Re: Proposed Changes to Technical Specifications  
License No. R-2, Docket No. 50-5

Three changes to the Technical Specifications (TS) for the Penn State Breazeale Reactor (PSBR) are proposed for your review and approval. The first change reflects a recent administrative change in the reporting chain for the reactor. The second change requests exemptions be added to several specifications to permit reactivity measurements for the reactor and for experiments without violation of the specifications. The third change increases the allowable pool water temperature recognizing the higher operating temperature for the demineralizer resins now in use. These changes were reviewed by the Penn State Reactor Safeguards Committee on January 11, 2000.

A copy of the proposed Technical Specification changes for TS 6.1.1 (pages 38 and 39), 6.2.4 (page 42), 6.5.2 (Page 44), 3.1.2 (page 10), 3.1.4 (page 11), 3.7.a & b (page 25), and 3.3.6 (page 21) is attached.

ORGANIZATION CHART

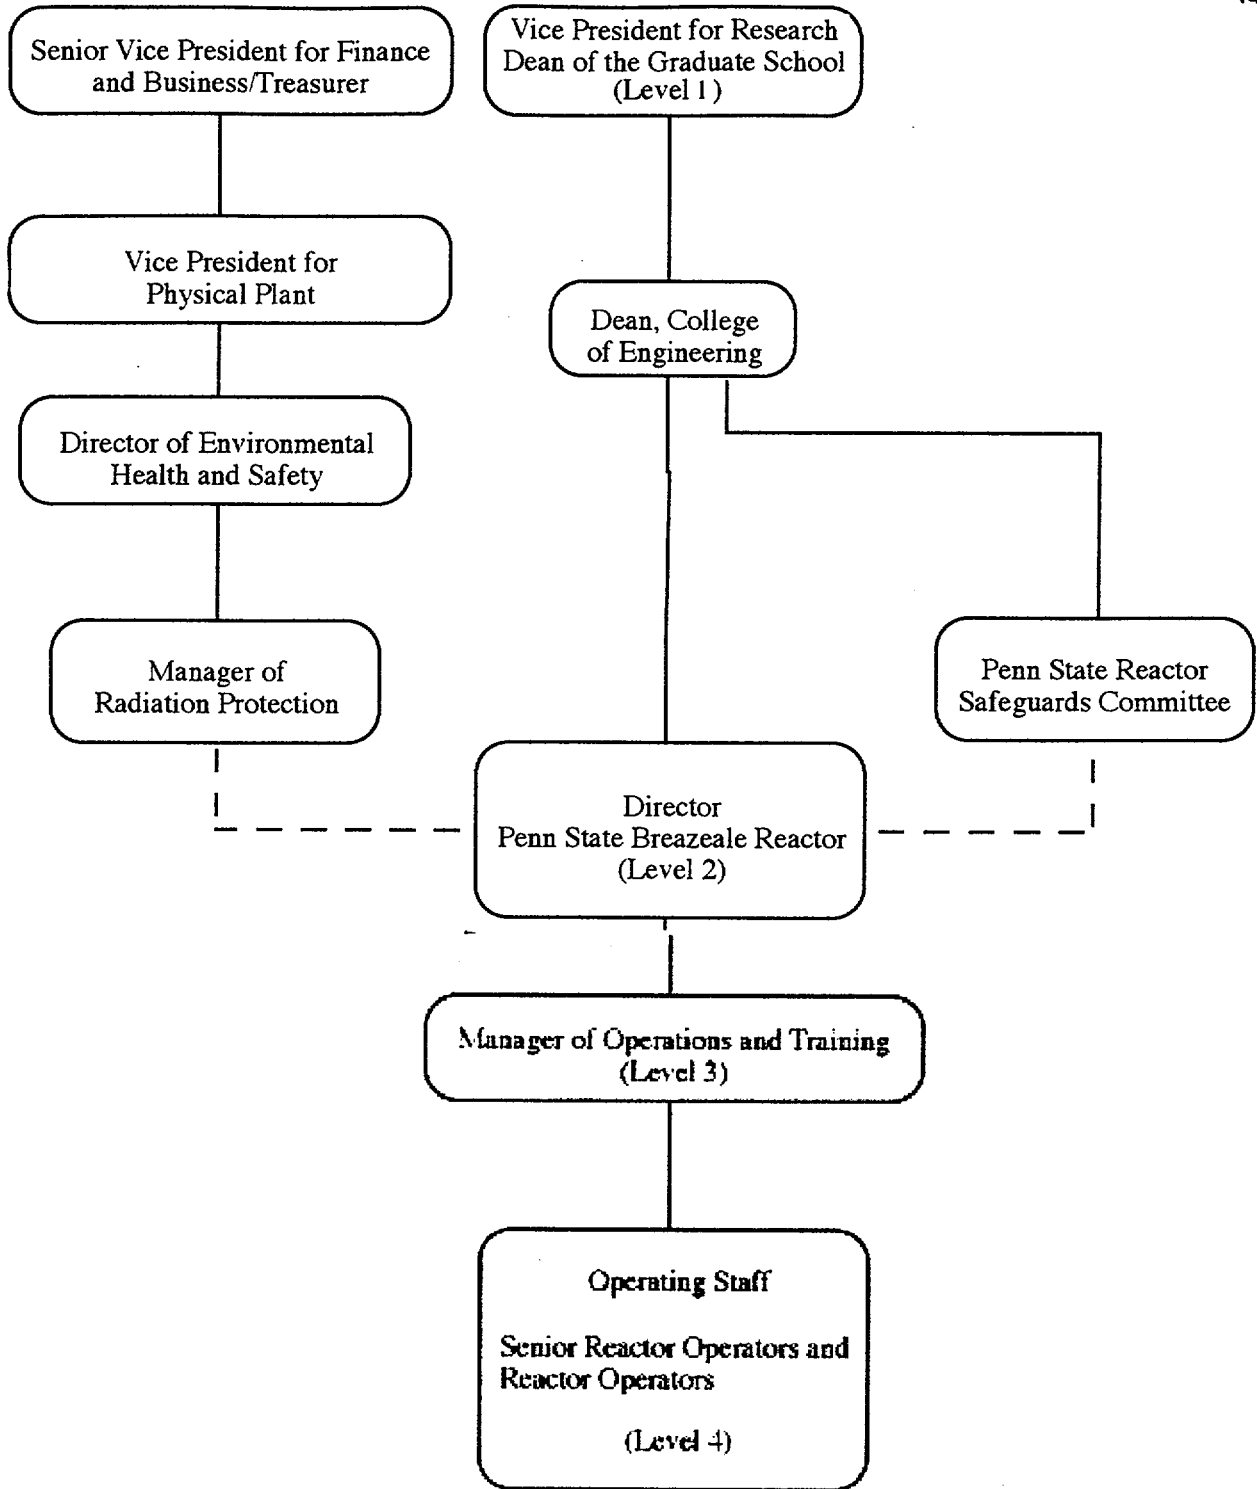
On December 8, 1999 the reporting chain for the Director of the PSBR (Level 2) was modified by the Vice President for Research, Dean of the Graduate School (Level 1) to have the Director report directly to the office of the Dean of Engineering. When the Nuclear Engineering Department was merged with the Mechanical Engineering Department to form the Mechanical and Nuclear Engineering Department (M&NE) in 1998, fiscal and administrative responsibilities for the reactor moved to the Dean's office in order to not unduly burden the M&NE Department Head and to assure that the reporting chain for the Director was not lengthened. The Nuclear Engineering Program Chair remained in the chain for historic reasons. Experience since the merger demonstrated that the administration of the reactor would best be served by shortening the reporting chain. The Nuclear Engineering Program Chair remains available to provide technical consultation to both the Director and the Dean's office; the Chair also remains as a resource in the reactor's emergency plan. The proposed changes to TS 6.1.1, 6.2.4, and 6.5.2 recognize this administrative change to the reporting chain.

The University Vice President for Research Dean of the Graduate School (level 1) has the responsibility for the reactor facility license. The management of the facility is the responsibility of the Director (level 2), who reports to the Vice President for Research, Dean of the Graduate School through the office of the Dean of the College of Engineering. Administrative and fiscal responsibility is within the office of the Dean.
